Olympic Peninsula Transmission Line Reinforcement Project

**Revision Sheet for the Environmental Assessment
Finding of No Significant Impact**

DOE/EA-1576
Bonneville Power Administration

Revision Sheet
for the
Olympic Peninsula Transmission Line Reinforcement Project
Final Environmental Assessment
DOE/EA -1576

Figure 15

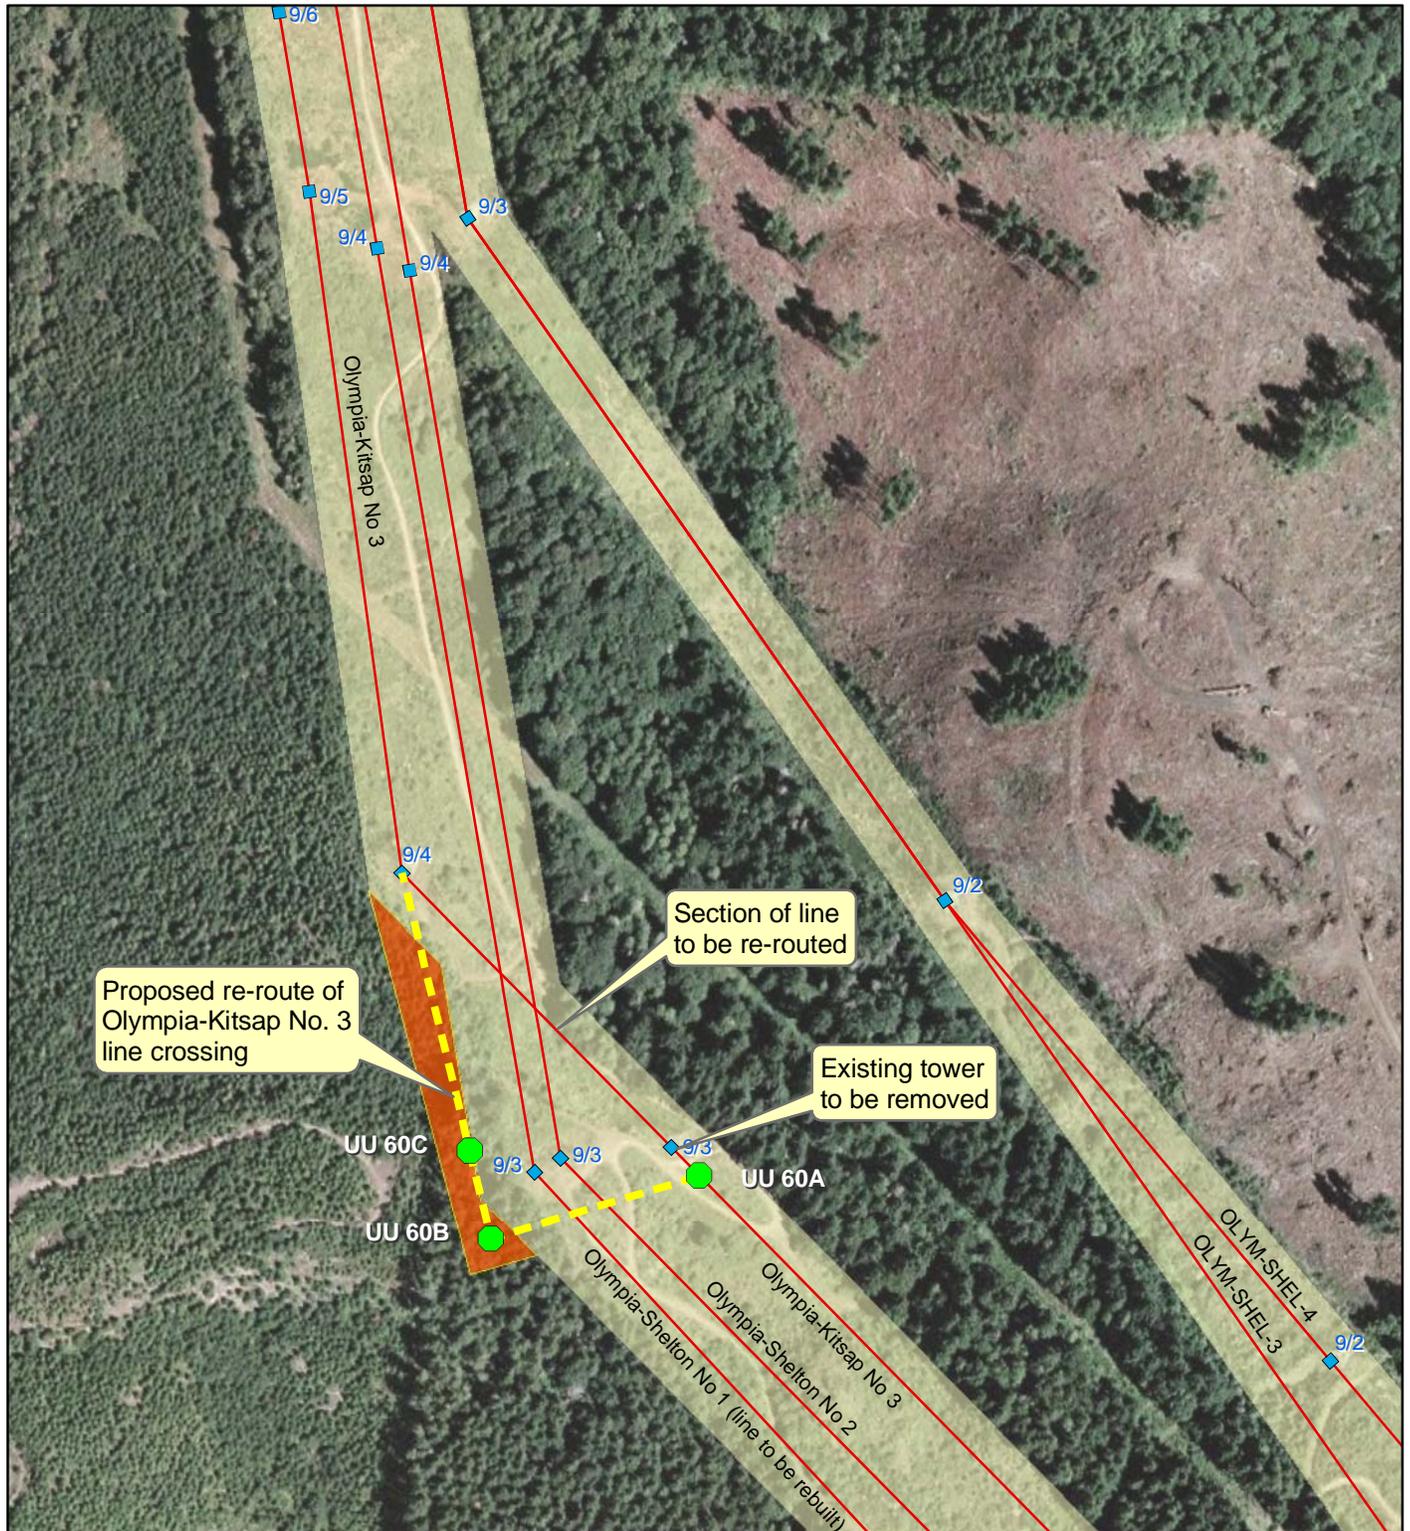
Please note that there has been a change in Mile 9 of the right-of-way which requires three additional new towers. Also, two towers that were proposed in wetlands in miles 11 and 12 have been moved out of wetlands. These changes to the Proposed Action necessitated changes in the text and the addition of Figure 15.

In Mile 9, the Olympia-Kitsap No. 3 line crosses over the existing Olympia-Shelton No. 1 line. Removing then rebuilding the Olympia-Shelton No. 1 line would require some changes on the Olympia-Kitsap No. 3 line. To avoid placing new structures on steep slopes, one existing tower on the Olympia-Kitsap No. 3 line would be removed, and one new lattice steel structure and two new H-Frame wood pole structures would be built on terrain less steep (see Figure 15). This change would require about 1.5 acres of new ROW on the west side of the transmission line corridor (see Figure 15).

In three locations, BPA would need to acquire additional ROW. In Mile 9, two new structures would be needed on new, permanent ROW (see Section 2.1.4 and Figure 15). About 1.5 acres of new ROW would be required.
